MACK SUBDIVISION (MINOR PLAT)

Staff Recommendation: Approval of the replat, subject to conditions in this staff report.

Updated: August 27, 2015

PROPOSED PLAT

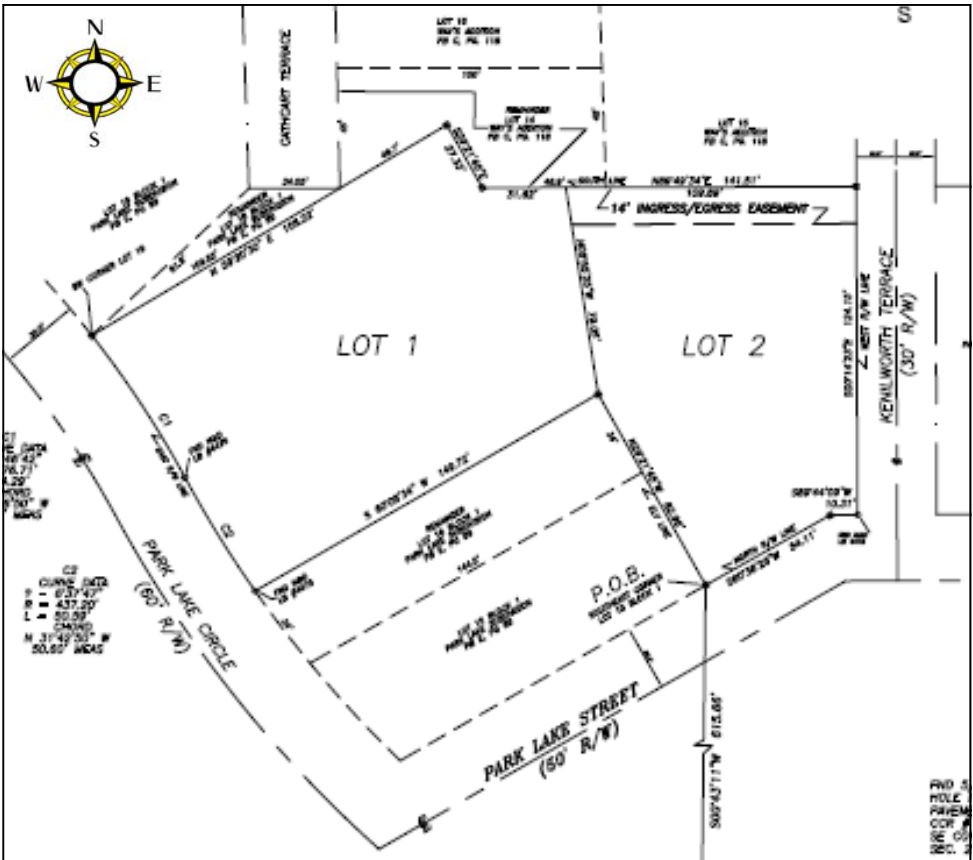
1. There are 2 mortgages on the subject property. A joinder & consent is required for each.
2. The book and page number shown on the joinder & consent that was provided is incorrect. It should be the book and page number of the mortgage, not the plat book & page number.
3. The plat appears to dedicate nothing to the public and must be stated as such in the dedication block.
4. Please have the surveyor provide a one-and-the-same letter certifying that the legal description shown on the plat describes the same area as the legal descriptions shown on the certificate of title.

1. The final plat shall contain the following note: "There shall be no building encroachment, roof-over-hang or underground structure within the easement."
